ADDENDUM NO. 2

Bid Package 13-01R

BROOKSIDE ELEMENTARY SCHOOL – BUILDING B  
DSA NO. 03-113415

OAK PARK UNIFIED SCHOOL DISTRICT

AD2-1

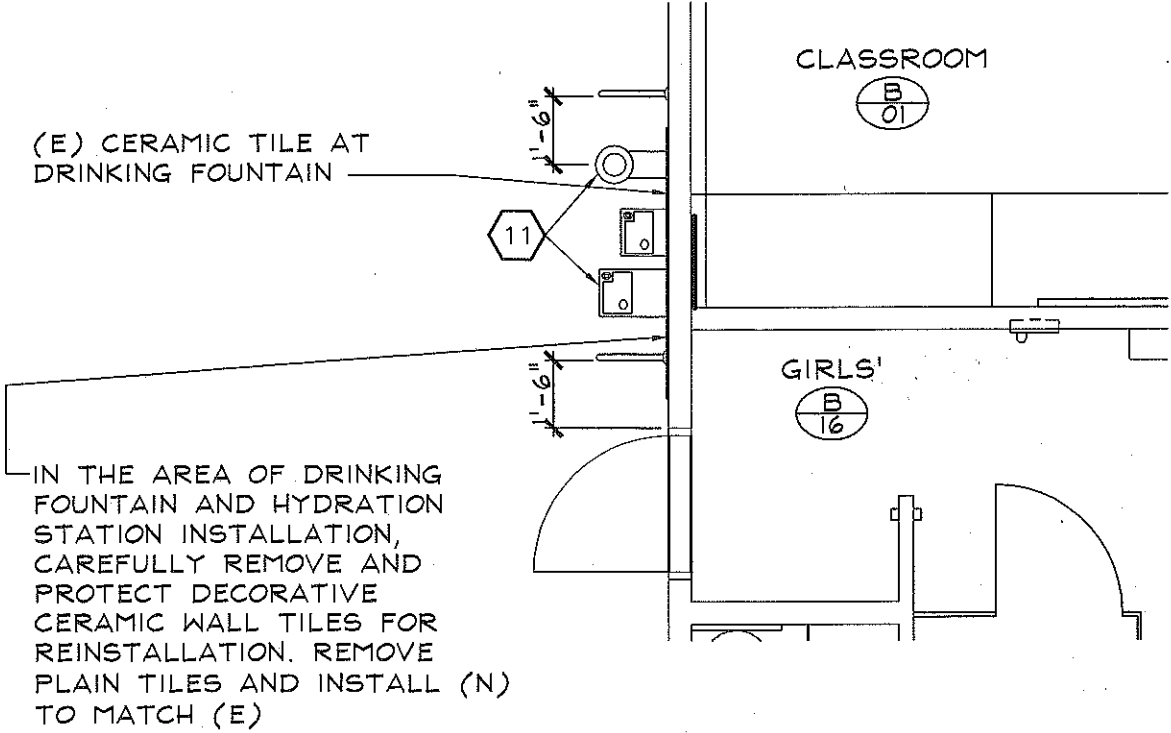
Refer to Drawing AD1-A2.2, dated January 7, 2013, Detail 2 and revise per the attached Drawing AD2-1, Detail 1, dated February 15, 2013.

Refer to Drawing AD1-A3.2, dated January 7, 2013, Detail 3 and revise per the attached Drawing AD2-1, Detail 2, dated February 15, 2013.

SCALE: 1/8" = 1'-0" REFER TO 3/AD1-A3.2, DATED 01-07-13  
FOR BALANCE OF WORK

SCALE: 1/4" = 1'-0" REFER TO 2/AD1-A2.2, DATED 01-07-13  
FOR BALANCE OF WORK

(N) OUTDOOR HYDRATION STATION  
 REMOVE CERAMIC TILE TO PROVIDE ADEQUATE AREA TO INSTALL BLOCKING AND MOUNTING PLATES (VERIFY ACTUAL AREA REQUIRED). REMOVE TILE BACK TO NEAREST GROUT JOINT. CAREFULLY REMOVE DECORATIVE TILE AND PROTECT FOR RE-INSTALLATION  
 LOCATE STUDS TO COORDINATE WITH DRINKING FOUNTAIN MOUNTING PLATE AND HYDRATION STATION INSTALLATION AND REQUIREMENTS. PROVIDE BLOCKING IN WALL FOR MOUNTINGS

(N) MOUNTING PLATE PROVIDED BY MANUFACTURER. INSTALLED BY CONTRACTOR PER MFR'S. INSTRUCTIONS

AD2-2

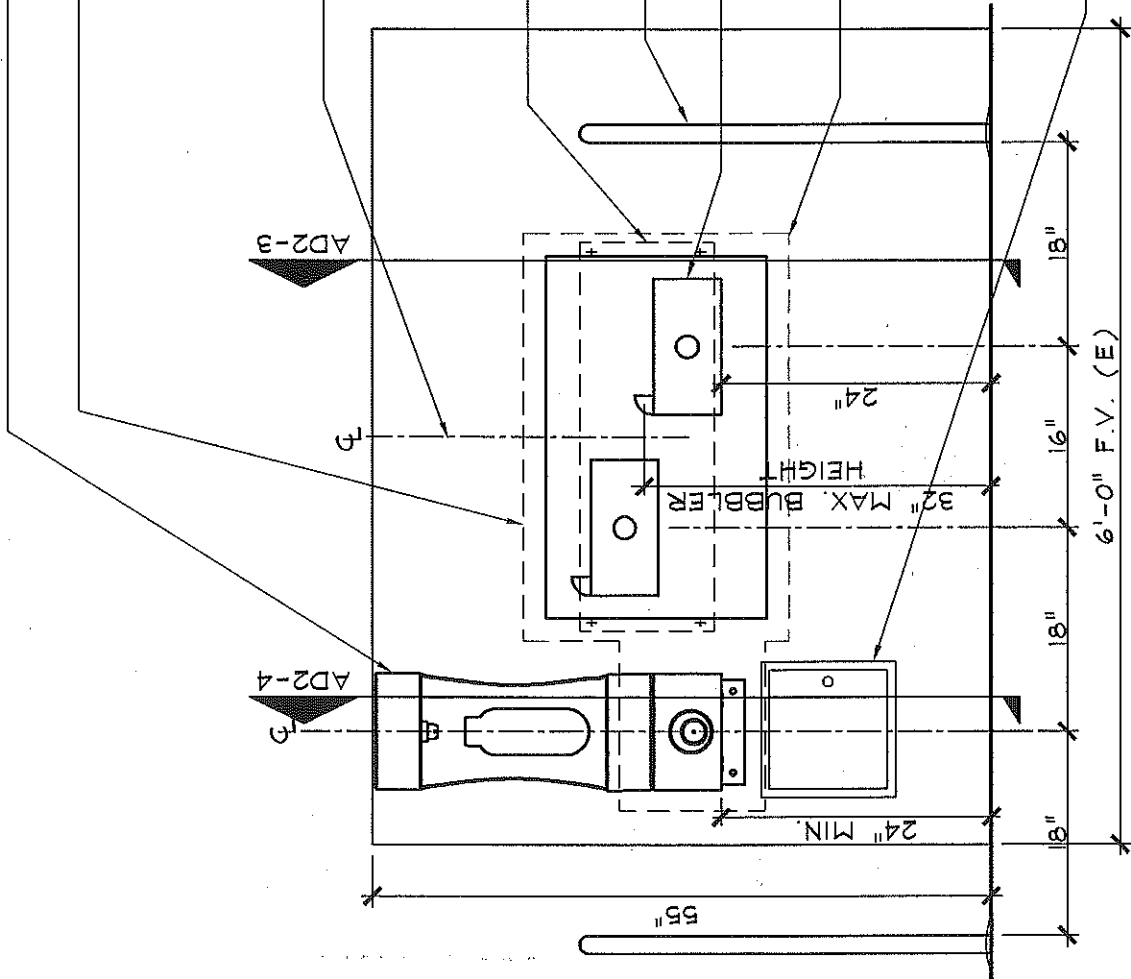
Refer to Drawing AD1-A6.60, dated January 7, 2013, delete Detail 10 and replace with the attached Drawing AD2-2, dated February 15, 2013.

(N) GUARDRAIL, RE: 11/ADI-A6.60, TYP. OF 2

(N) ACCESSIBLE HI-LO DRINKING FOUNTAIN WITH BACK PANEL, RE: PLUMBING FIXTURE SCHEDULE, AD2-PI

(E) CERAMIC TILE TO REMAIN, PROTECT IN PLACE. REMOVE TILE FOR INSTALLATION OF FIXTURES. CAREFULLY REMOVE DECORATIVE TILE AND PROTECT FOR RE-INSTALLATION. REMOVE FIELD TILE AND INSTALL (N) CERAMIC TO MATCH (E)

(N) 12"x12" S.S. ACCESS PANEL. CAREFULLY CUT TILE TO RECEIVE PANEL

DRINKING FOUNTAIN MOUNTING HEIGHTS REFER TO AC.1 AND MFR. INSTALLATION INSTRUCTIONS

NOTE: CONTRACTOR ALSO TO PROVIDE ELECTRICAL, WATER AND SEWER

AD2-3

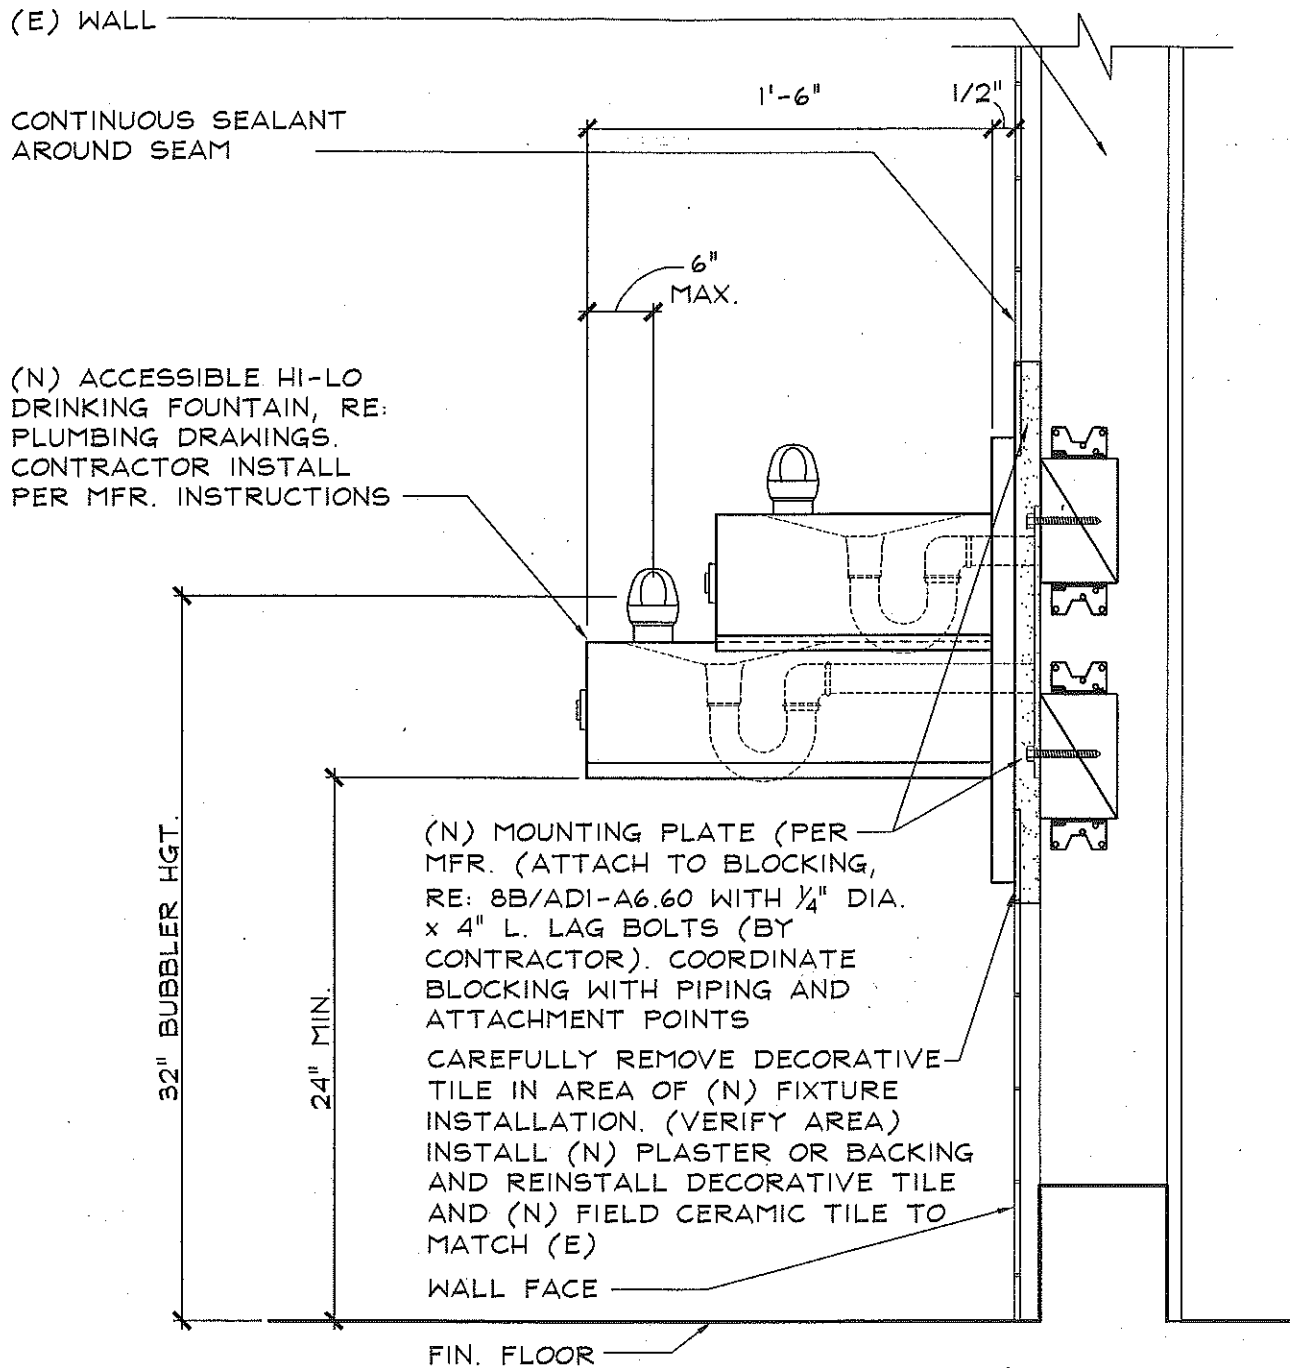
Refer to Drawing AD1-A6.62, dated January 7, 2013, delete Detail 7 and replace with the attached Drawings AD2-3 and AD2-4, dated February 15, 2013.

**AD2-P2**

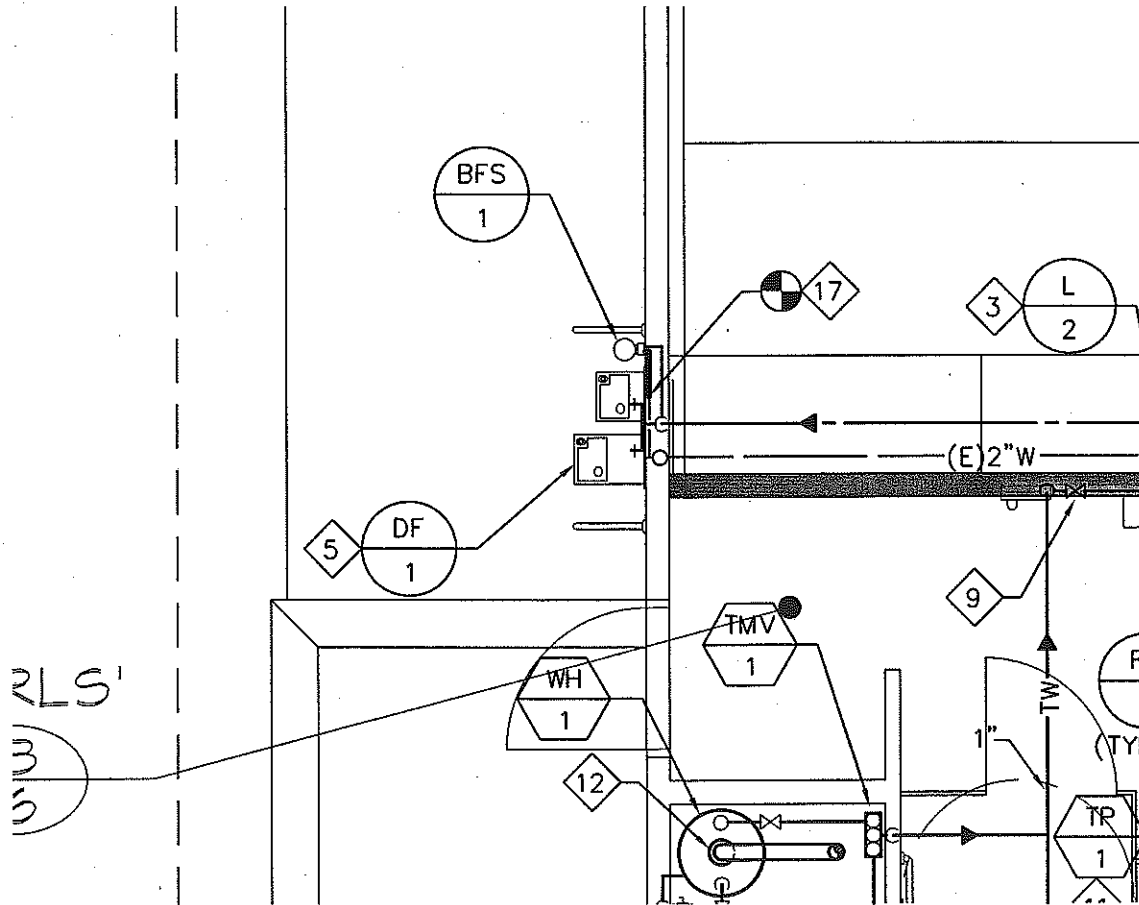
Refer to Drawings AD1-P2.2a, Detail 1, dated January 7, 2013 and revise the plan per the attached Drawing AD2-P2, dated February 15, 2013.

◇ 17 POINT OF CONNECTION, 1 1/4" WASTE TO (E) 2" WASTE IN WALL.
